DEPARTMENT OF THE AIR FORCE
DETACHMENT 1, AERONAUTICAL SYSTEMS CENTER (AFMC)
PRODUCTION FLIGHT TEST INSTALLATION, AF PLANT 42
2503 EAST AVE P, PALMDALE CA 93550-2196

SUBJECT: Palmdale Hybrid Power Plant – Initial Comments on AFC Conceptual Site Plan

1. We have received your request to review the subject Conceptual Site Plan, Drawing No. 2007-021-CM-500, Revision D, dated 3-11-10 (attached), and have carefully reviewed it with respect to the Avenue M Earthen Berm, the Infiltration Basins, Development Setbacks, Security Cameras, Electrical Transmission Lines, Visible/Thermal Plumes and Power Plant Exhaust Stacks. The following comments are provided for your consideration.

SECTION X-X BERM ALONG AVENUE M AND WEST OF S
SCALE: NTS

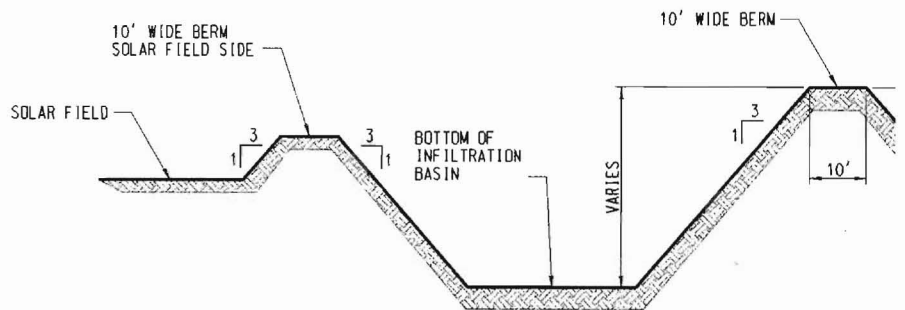
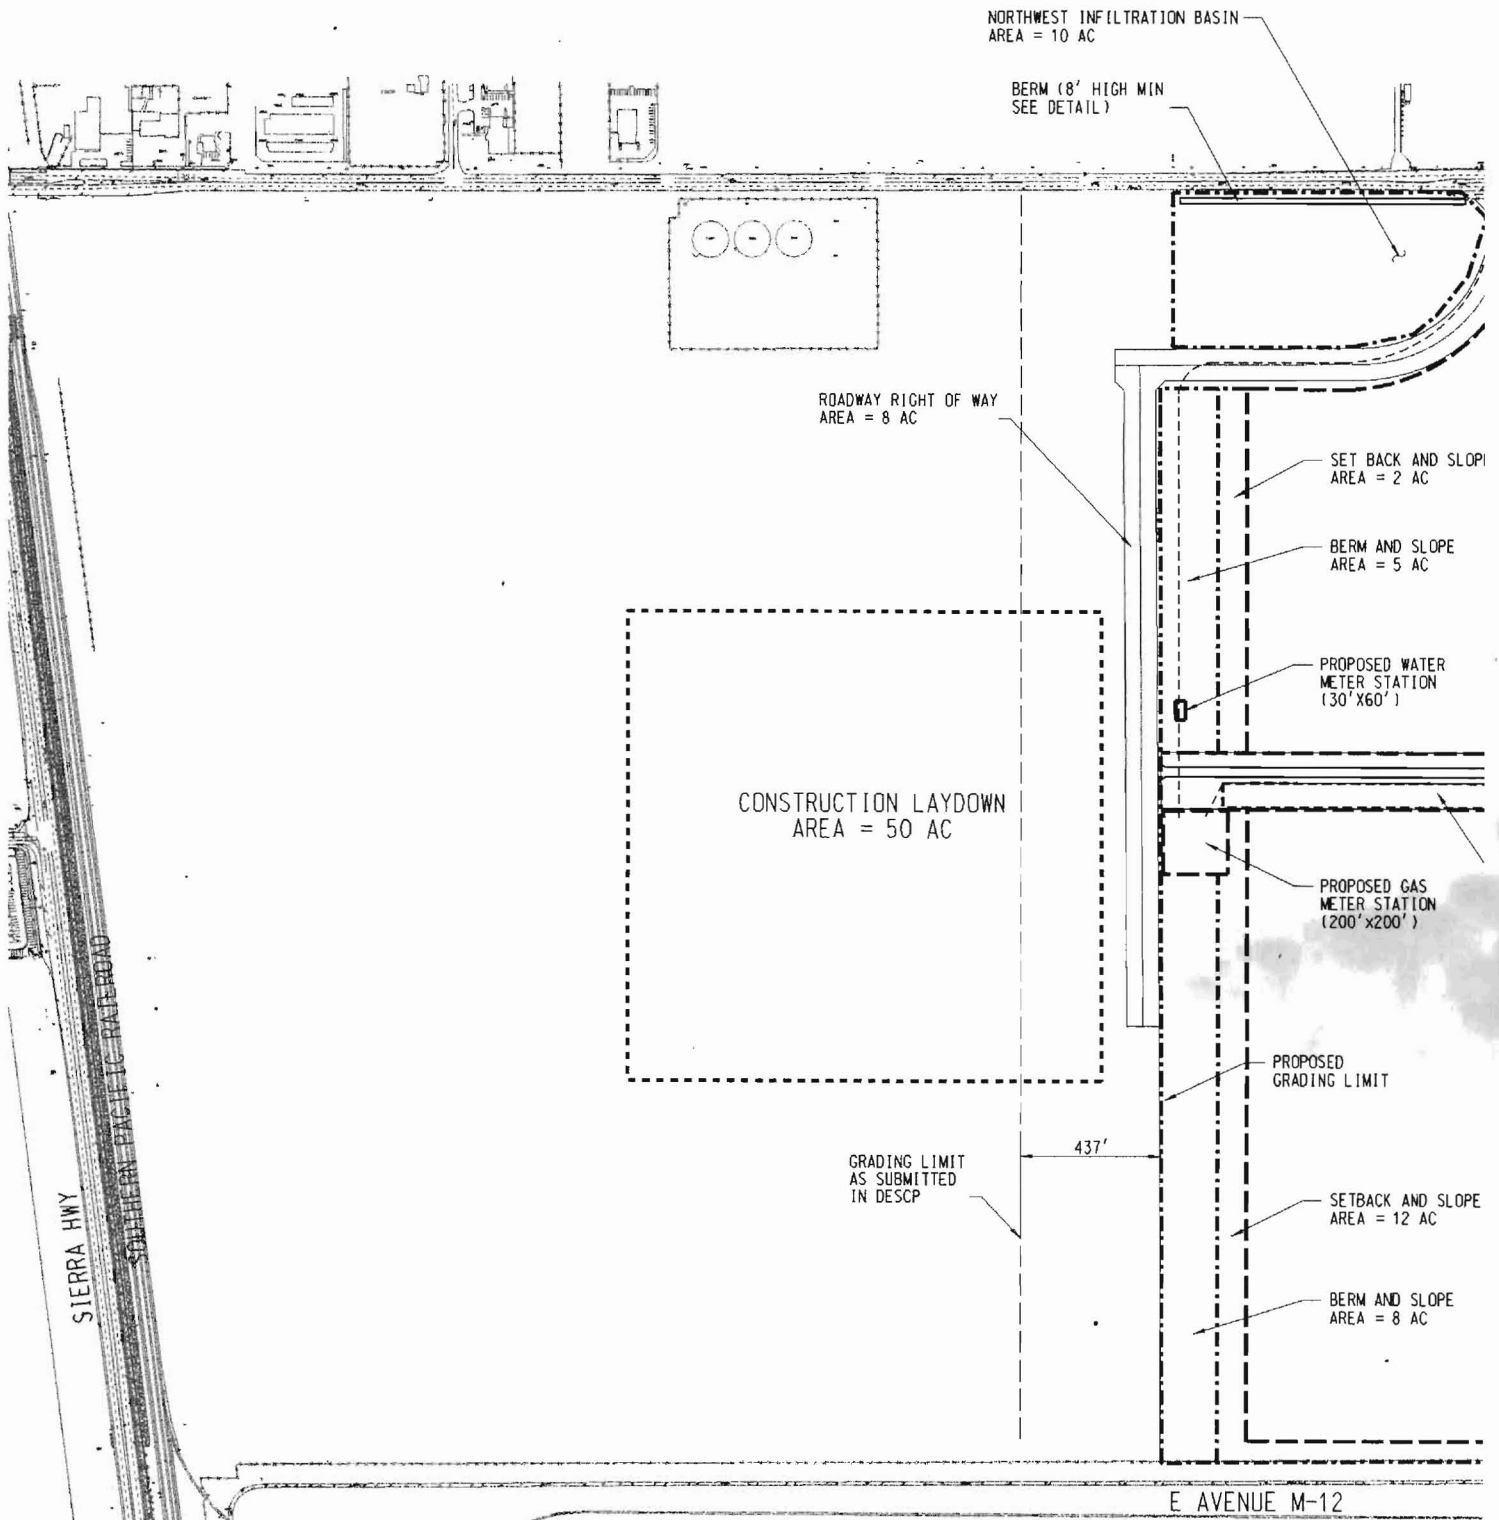
2. Avenue M Earthen Berm: We understand the purpose of the berm (8' min.) is to mitigate the visual impacts to the north of the site, and that the berm will be landscaped with desert vegetation. We assume that dust and debris mitigation will be required on the berm (before, during and after construction). Other than the voluntary 20 feet setback from Plant 42 property line (noted herein), we take no exception to the berm as presented, and foresee no negative impacts to Air Force Plant 42 with dust and debris mitigation.

3. Infiltration Basins: We understand the purpose of the infiltration basins is to mitigate the stormwater runoff impacts from the site, that the basins will percolate/evaporate storm water runoff from the power plant property within 48 hours, that measures will be taken to ensure that the basins do not attract migratory waterfowl, and that there will be no connection to Air Force Plant 42 property. We assume that dust, debris and migratory waterfowl mitigation, will be required for the infiltration basins (before, during and after construction). We take no exception to the infiltration basins as presented, and foresee no negative impacts to Air Force Plant 42 with dust, debris, and migratory waterfowl mitigation.

4. Development Setbacks from Plant 42: Pursuant to discussions with the City of Palmdale, and as validated on the subject site plan, the site is designed to provide a development setback of 20 feet upon the power plant along the east and south boundaries of the site, adjoining Plant 42. The primary purpose of the 20 feet setback is to maintain a security standoff distance from Plant 42 property line, and that this setback will continue in perpetuity through a deed restriction or other legal mechanism on the power plant property. Other than the noted setback perpetuation, we concur with the setback as presented, and foresee no negative impacts to Air Force Plant 42.

8. Power Plant Exhaust Stacks: The nearest runway to the site is Plant 42 Runway 07-25, and it is our understanding that the exhaust stack structure nearest to that runway is one of the HSRG exhausts, which is approximately 3,200 feet to the north of the centerline of the subject runway. Based on the subject offset distance, the nearest HSRG exhaust stack is restricted to a height of 150 feet above the runway surface elevation of 2543 MSL, as it falls under the control of the Inner Horizontal Surface found in Figure 3-15 of UFC 3-260-01. It is our understanding that the City of Palmdale plans to limit the height of any stack to 140 feet above the final finished grade of the site (planned for elevation 2517 MSL).

Figure 3-15. Class B Army and Air Force Runway Airspace Plan and Profile
Runway Imaginary Surfaces

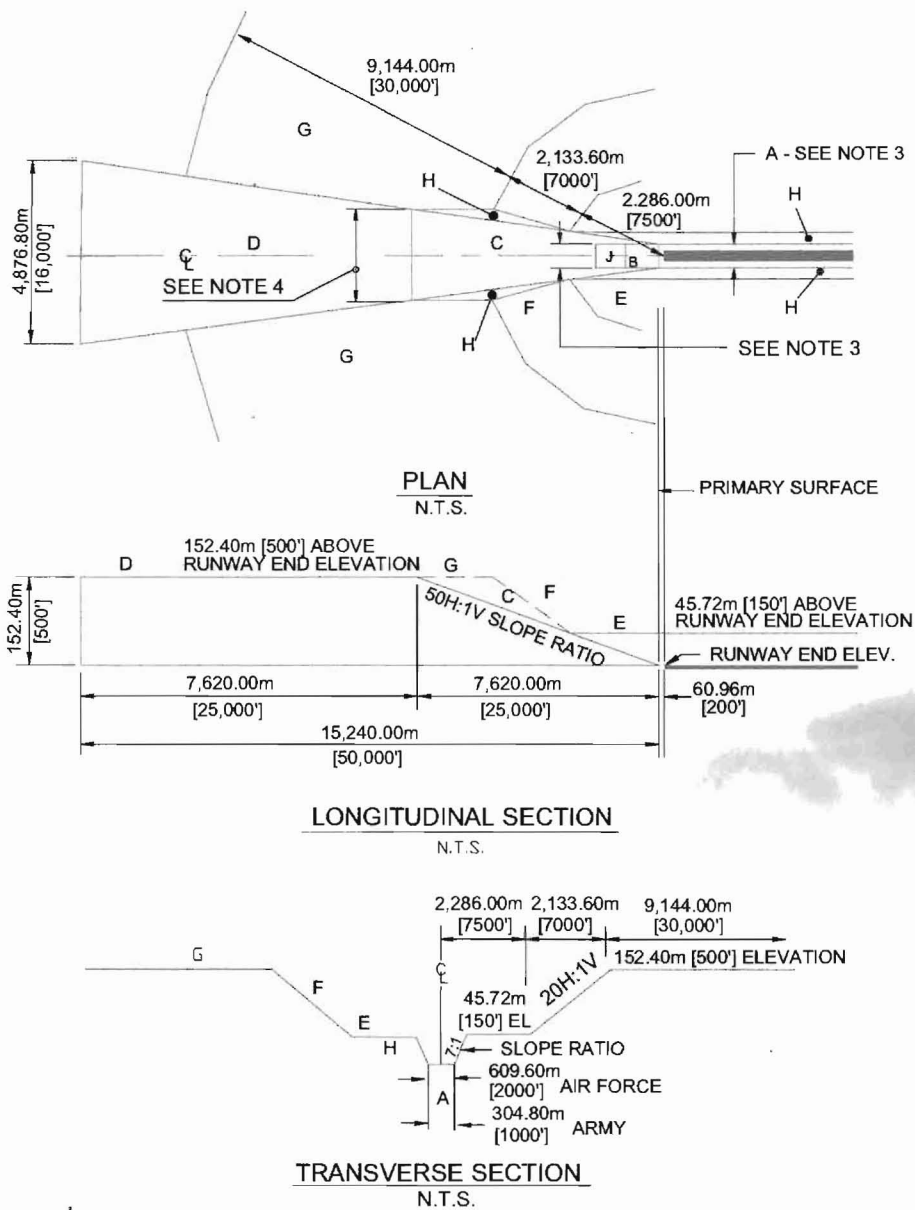
- a. Preferred Route: Along Avenue L, near 60th Street East, the poles are approximately 12,000 feet from the end of Plant 42 Runway 22 (Approach End - north end of Runway 04-22) within Plant 42 Accident Potential Zone II (APZ II). Pursuant to Figure 3-15 of UFC 3-26-01, these poles are within Plant 42's military airport airspace. It is our understanding that the City of Palmdale intends to restrict all poles, within Plant 42's military airport airspace, to single pole structures no greater than 120 feet in height; in any case, these poles would have to be restricted to a height of 240 feet above the runway surface elevation of 2543 MSL at the most critical locations. While there are inherent risks with any above ground structures located within airport flight paths, this preferred route poses the least risk amongst all the potential routes identified; we therefore take no exception to the pole locations and heights as presented, and foresee no negative impacts to Air Force Plant 42.

- b. Alternative Route 1: Along 10th Street West, near Avenue N, the poles are approximately 10,100 feet from the end of Plant 42 Runway 07 (Approach End - west end of Runway 07-25) within Plant 42 Accident Potential Zone II (APZ II). Pursuant to Figure 3-15 of UFC 3-26-01, these poles are within Plant 42's military airport airspace. It is our understanding that the City of Palmdale intends to restrict all poles, within Plant 42's military airport airspace, to single pole structures no greater than 120 feet in height; in any case, these poles would have to be restricted to a height of 198 feet above the runway surface elevation of 2543 MSL at the most critical locations. While there are inherent risks with any above ground structures located within airport flight paths, this alternative route poses the least risks amongst the alternative routes identified; we therefore take no exception to the pole locations and heights as presented, and foresee no negative impacts to Air Force Plant 42.

- c. Alternative Route 2: Along Division Street, near Avenue N, the poles are approximately 4,900 feet from the end of Plant 42 Runway 07 (Approach End - west end of Runway 07-25) within Plant 42 Accident Potential Zone I (APZ I). Pursuant to Figure 3-15 of UFC 3-26-01, these poles are within Plant 42's military airport airspace. It is our understanding that the City of Palmdale intends to restrict all poles, within Plant 42's military airport airspace, to single pole structures no greater than 120 feet in height, and that the system along Division Street within the military airport airspace would be undergrounded, thereby eliminating the potential conflicts to the airport; if the transmission lines are not undergrounded, these poles would have to be restricted to a height of 94 feet above the runway surface elevation of 2543 MSL at the most critical locations. While there are inherent risks with any above ground structures located within airport flight paths, this alternative route, if not undergrounded, would pose a substantially greater risk than Alternative Route 1.

- d. Alternative Route 3: Along Sierra Highway, near Avenue N, the poles are approximately 3,600 feet from Plant 42 Runway 07 Approach End (west end of Runway 07-25) within Plant 42 Accident Potential Zone I (APZ I). Pursuant to Figure 3-15 of UFC 3-26-01, these poles are within Plant 42's military airport airspace. It is our understanding that the City of Palmdale

intends to restrict all poles, within Plant 42's military airport airspace, to single pole structures no greater than 120 feet in height, and that the system along Sierra Highway within the military airport airspace would be undergrounded, thereby eliminating the potential conflicts to the airport; if the transmission lines are not undergrounded, these poles would have to be restricted to a height of 68 feet above the runway elevation of 2543 MSL at the most critical locations. While there are inherent risks with any above ground structures located within airport flight paths, this alternative route, if not undergrounded, would pose a greater risk than Alternative Route 2.
